Project No. 2016-5619000

**RE: Seniors Living Reservoir Road, Blacktown - Masterplan
Blacktown Workers Sports Club Stormwater Management Report
Peer Review Comments**

Warren Smith and Partners (WS+P) has been engaged by Paynter Dixon Constructions to undertake a peer review of the Blacktown Workers Sports Club Stormwater Management Report, undertaken by Wood and Grieve Engineers on the 21st December 2015, for Site B – Seniors Living Village. Site A has been approved by Council and is currently under construction. Please refer to Figure 1 for a location plan of Site B.

Figure 2: Areas subject to OSD (Source: BCC)

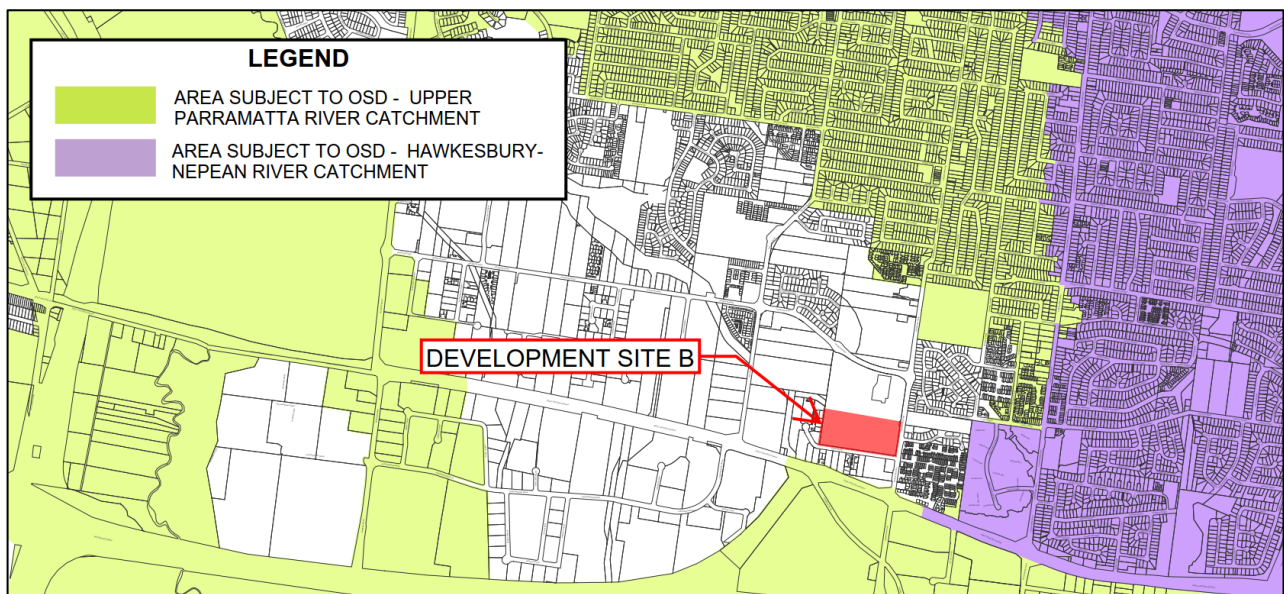
1. As discussed previously, an attenuation structure will not be required as part of the proposed development. Refer to Figure 2 for a location plan of areas with BCC which are subject to OSD in relation to the proposed site.
